Technical Note

Project Mayfield 2020 Appointment
Subject Hydraulic Modelling – Mayfield Park Phase 1 Full Build Out
Project no 0046688
Date 20 April 2021

Revision	Description	Issued by	Date	Approved (signature)
00	Issue to Environment Agency	HM	22/01/2021	JF
01	Update following Environment Agency review	HM	24/02/2021	JF
02	Update following EA review of Condition 66 details	JF	20/04/2021	CB

Figure 3-1: Representation of proposed channel interventions within hydraulic model

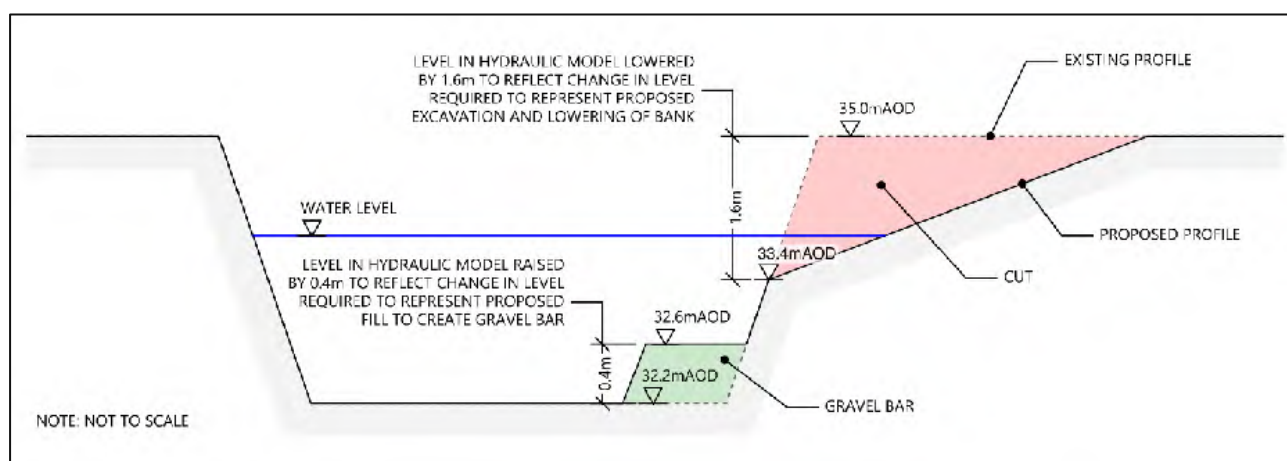
With regards to the channel and bridge geometry, in order to be clear and ease my review, please add detail of how the elevations have been calculated including figures of channel/structure design within the reporting itself.

Therefore, in order to determine the impact of the proposed interventions on flood levels and extent, the cross-sectional profiles of the Full Build Out model have been altered to reflect the *change* in level between the 2020 surveyed levels and the proposed interventions. This approach can be summarised as follows and is shown diagrammatically in Figure 3-1.

Change in level within hydraulic model = Proposed cross-sectional profile – existing cross-sectional profile (2020 survey)

Figure 3-5: Plots of cumulative mass error against time for the 25 year, 100 year and 100 year + 35% CC events, showing relative performance of the amended Full Build Out model (197) compared to the BHE Baseline 2020 model (142) and the previous Full Build Out model (192)

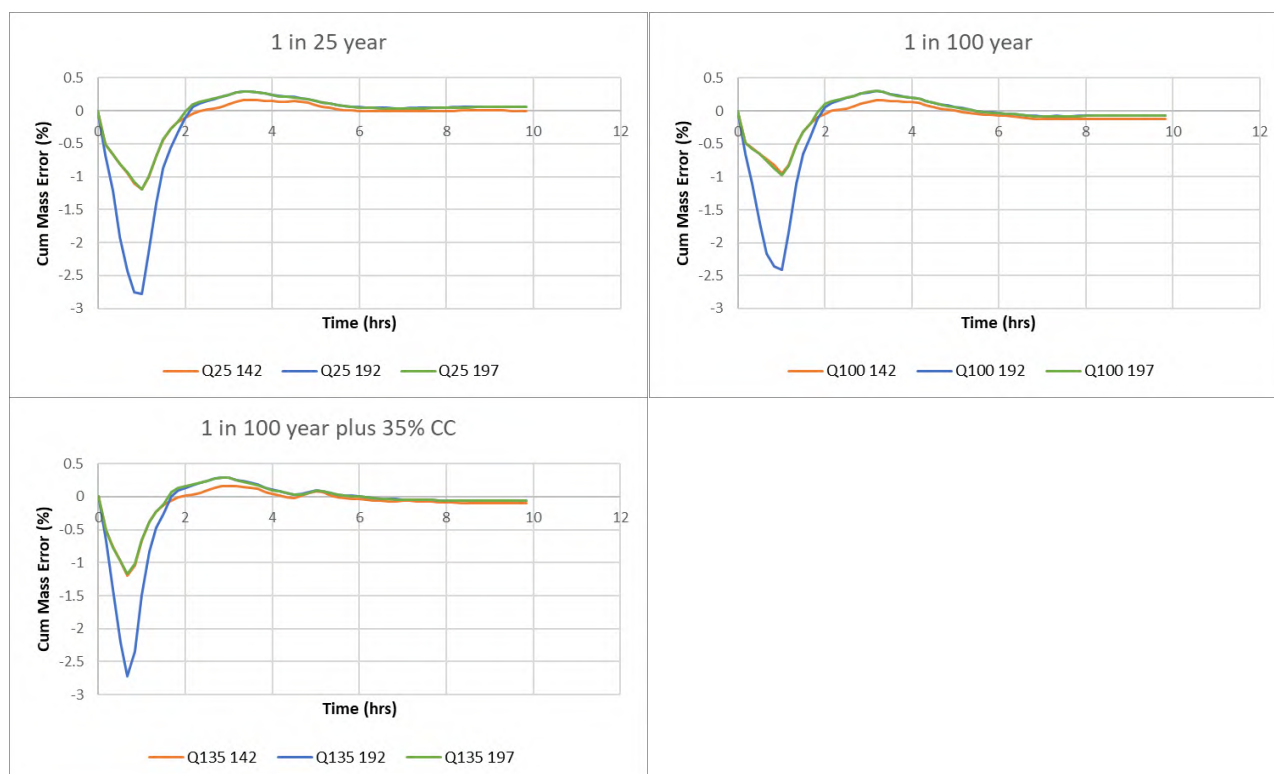
In the version of the Full Build Out model submitted along with Rev. 00 of this report (model no. 192), the mass error peaked at approximately -2.5%. It was identified that the accumulation of mass error occurred between the hours of 0 and 2, when flow in the river is low, and in-channel water levels are very similar to the low point of the left bank adjacent to the Wildscape area, circled in red in Figure 3-4. This causes constant flux between the 1D and the 2D domains, with no clear dominant flow direction. It is concluded that this flux is the cause of the peak in mass error.

This amendment is considered a more accurate representation of the proposed scheme, rather than a design change, and does not have an impact on water levels elsewhere within the model.

Figure 3-5 provides a graphical comparison of the performance of the amended Full Build Out model (197) against the BHE Baseline 2020 model (142) and the previous iteration of the Full Build Out model (192) for each of the return periods tested.

Figure 1: Baseline water level at the Wildscape area, annotated with location of cause of mass error

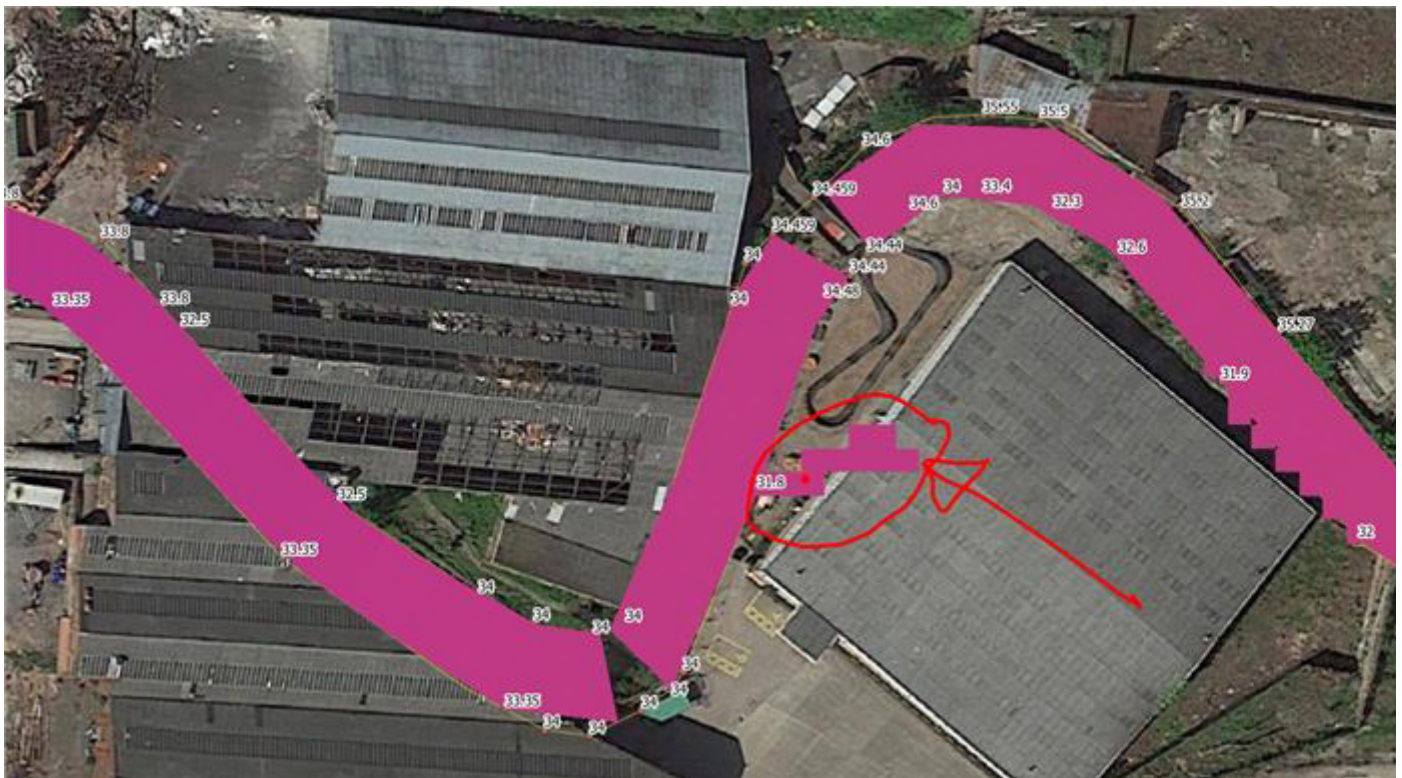
We have been investigating the mass balance error with regard to Item 14.1 in the model review spreadsheet, and thought it would be helpful to provide an update in advance of reissuing our deliverables formally.

- Accumulation of mass error occurs between the hours of 0 and 2, when flow in the river is low, and in-channel water levels are very similar to the low point of the bank;
- This causes constant flux between the 1D and the 2D domains at the part of the Wildscape area circled in the image in Figure 1, with no clear dominant flow direction;
- Concluded that this flux is the cause of the peak in mass error, as cumulative mass error begins to reduce as water levels increase (Figure. 2).

- Raise bank height from 31.8mAOD to 32mAOD locally, at inflow point from channel to Wildscape area, to match proposed level for low point of Wildscape area
- This prevents movement between 1D and 2D domain during low flow state (hours 0 to 2) and significantly reduces the mass error (Table 1 and Figure 3)
- This amendment is considered a more accurate representation of the proposed scheme, rather than a design change, and does not have an impact on water levels elsewhere within the model
